YOUNG ENGINEERING SERVICES

Consultation - Plan Review
Escutia Residence Rebuild
Lot 19, Royal Glen Subdivision
3719 Paxton Place
APN 173-460-019
GPS: Lat/Long N38.4844, W122.6911
Santa Rosa, CA

RETAINING WALL DETAILS

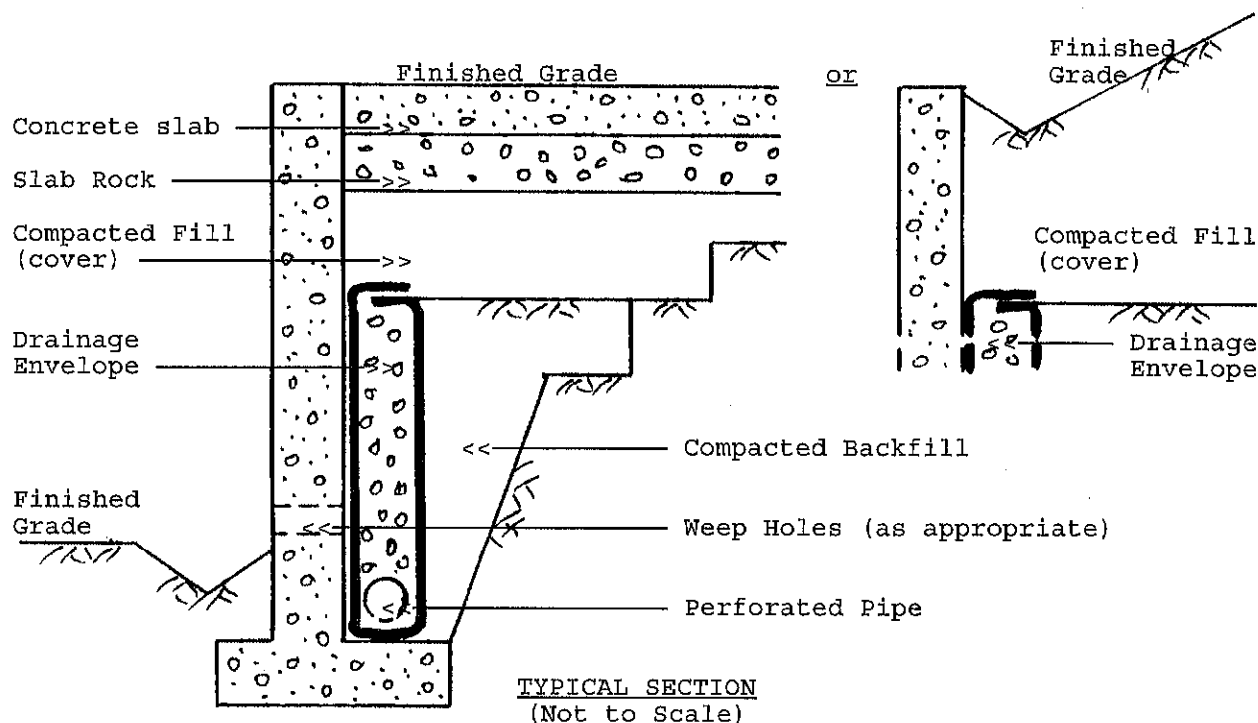
The drainage for the wall backdrains should conform to the attached Retaining Wall Details. Where this drain is immediately adjacent to a slab-on-grade floor (i.e., the garage floor and master bedroom floor slabs), the flow line of the perforated collector pipe should be at least 8 inches below the finished surface of the slab and should be at least 8 inches above the bottom of the footing excavation.

An expedient and economical solution for this drainage envelope would be to use a composite synthetic drainage material (eg, Miradrain or equal), also discussed on the attached Retaining Wall Details. The composite drain system is well suited for footings poured "neat" (without forming, as indicated on the plans), and should be placed along the upslope wall of the footing excavation prior to footing pour. To relieve this drainage envelope, a perforated pipe and typical drainage envelope (drain rock wrapped in geotextile filter fabric, or perforated pipe wrapped in the composite fabric) should be in contact with the ends of the drain for a distance of at least 5 feet.

1. Compacted Fill (cover). The drainage envelope should be capped by a compacted soil cover a minimum of 12 inches thick. This cover blanket may be omitted where the surface is paved.

2. Drainage Envelope. To minimize potential for clogging of retaining wall drainage, the drainage envelope should also be separated from the soil by use of a Geotextile Filter Fabric (Mirafi 140NP or equal).
or utilize a select Permeable Material (per Section 68 of Caltrans Standard Specifications) for backfill.
or utilize a Composite Geosynthetic Drainage System (Miradrain or equal). To relieve this drainage envelope, a perforated pipe and typical drainage envelope (drain rock wrapped in geotextile filter fabric, or perforated pipe wrapped in the composite fabric) should be in contact with the ends of the drain for a distance of at least 5 feet.

3. Perforated Pipe. The perforated pipe should conform to the requirements of Section 68 of Caltrans Standard Specifications, perforations placed down, sloped at least one percent to drain to a gravity outlet.
or Weep Holes. Where water draining in front of the wall is acceptable, weep holes should be placed at six foot spacing. Weep holes can consist of 2 inch PVC cut to fit within the foundation stem wall, with the ends wrapped in hardware cloth (one-quarter inch sieve openings) to minimize clogging, and prevent access from rodents.

4. Compacted Backfill. The compacted backfill should be keyed and benched into the backslope. The width and location of benches are approximate, and will be determined in the field by a representative of YES!.

5. Surface drainage is to be provided at the toe of the retaining wall.
